City Council Meeting

July 17, 2024

Item #4: Flawless or Flawed?

As presented by CRCRC in May 28, 2024 Meeting Agenda Packet

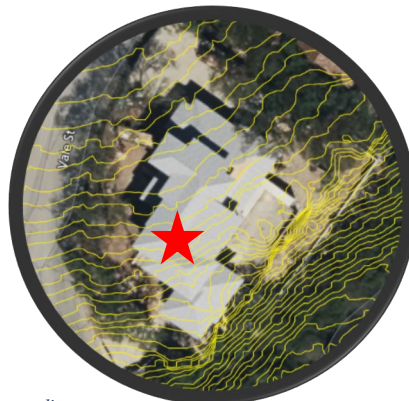
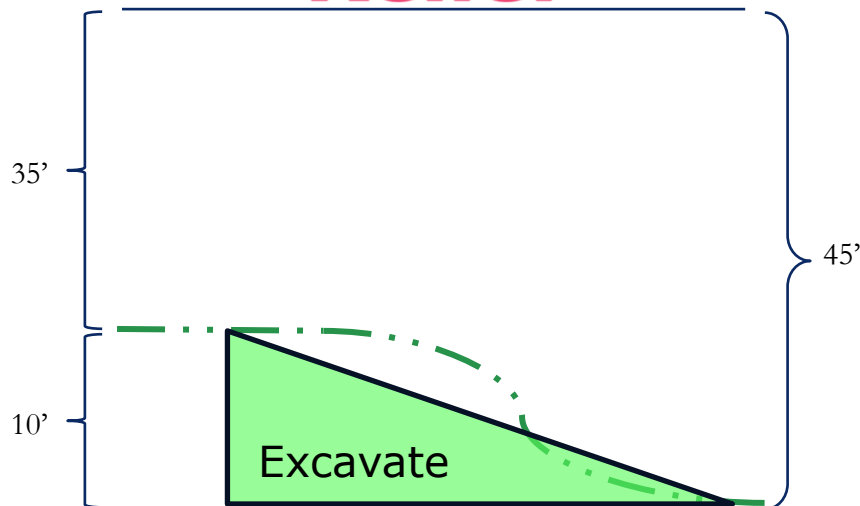
Measurements Per Architecture Plans:
 Existing Grade beneath Ridge Line = 543'
 Building Height at Ridge Line = 581'
Max Building Height = 38'

Measurements Per Architecture Plans:
 Existing Grade beneath Ridge Line = 628'
 Building Height at Ridge Line = 664' 2"
Max Building Height = 36' 2"

*CRCRC's work said this home would be approved, but in fact, it would **not** be approved*

*CRCRC's work said this home would be approved, but in fact, it would **not** be approved*

Item #4: Flawless or Flawed?

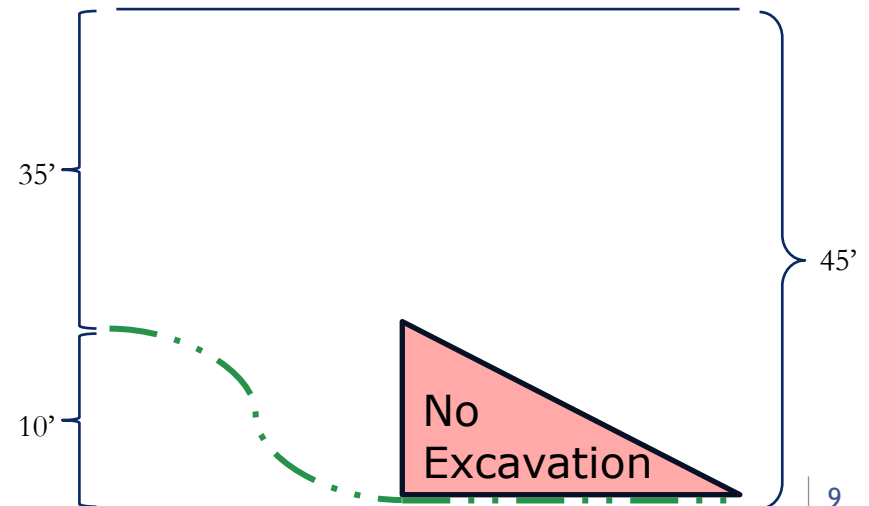
- Within the CRCRC's parallel plane proposal is a new concept, which allows for any excavation that occurs below the existing grade will not count toward the maximum building height calculation, as found in the 07/07/2024 City Council Agenda Packet (p 251)
 - “Figuring Maximum Allowable Height”
 - *Bullet #6*: “There is no limit to the amount of building that may be added below existing grade by way of excavation.”*
- This proposal has never been discussed in the entire time the CRCRC has existed, but it appeared for the first time at the June 25, 2024 meeting and was pushed forward.
- Even though there were numerous other proposals from the CRCRC members or the public that create “equity” amongst all lots they ignored them and created a rule that further creates “winners” and “losers”

- If a resident's lot is fairly flat but has a material amount of topo at one portion of their lot they could excavate a large portion of their lot gain an additional 10'. This is a huge advantage to this lot

- In the opposite situation, if a resident's lot has topo that quickly drops there is nothing for them to excavate. In this situation they are forced to follow the parallel plane and would have no relief

* *Bullet 6 contradicts Residential Building Height Measurement proposed by the CRCRC (page 246 and 250 of Agenda Packet)*

Item #4: Flawless or Flawed?

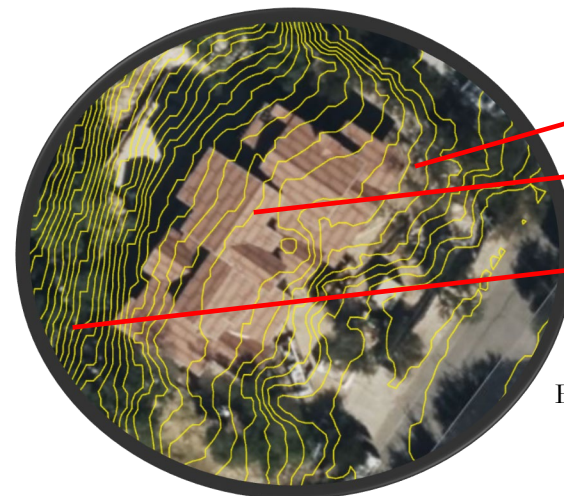
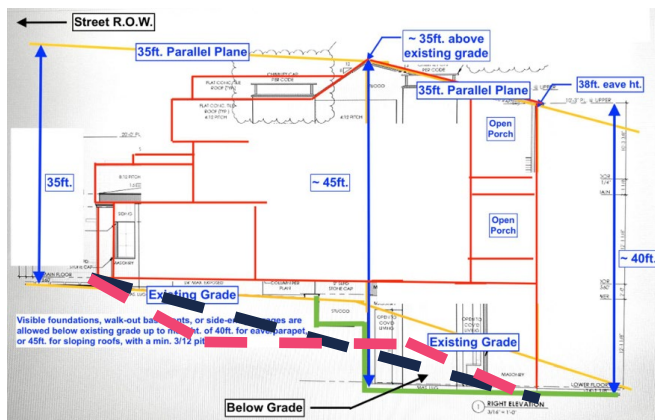
- The two homes below, which were noted on previous pages and were provided in the June 25, 2024 CRCRC Agenda Packet as homes that would be “approved” under the current proposal, in fact, would not be approved
- Both of the homes exceed 35’ height from the existing grade, irrespective of the additional height they received by excavating
 - The home on the left has a **Maximum Height** from the existing grade of **40.85’**
 - Existing Grade beneath ridge line = 622.5’
 - Building Height at ridge line = 663.35’
 - The home on the right has a **Maximum Height** from the existing grade of **37.25’**
 - Existing Grade beneath roof line = 623’
 - Building Height at roof line = 660.25
- This is another example showing that the CRCRC has does not have a firm grasp of what they are proposing, how it works and how it impacts our lots, neighbors and community
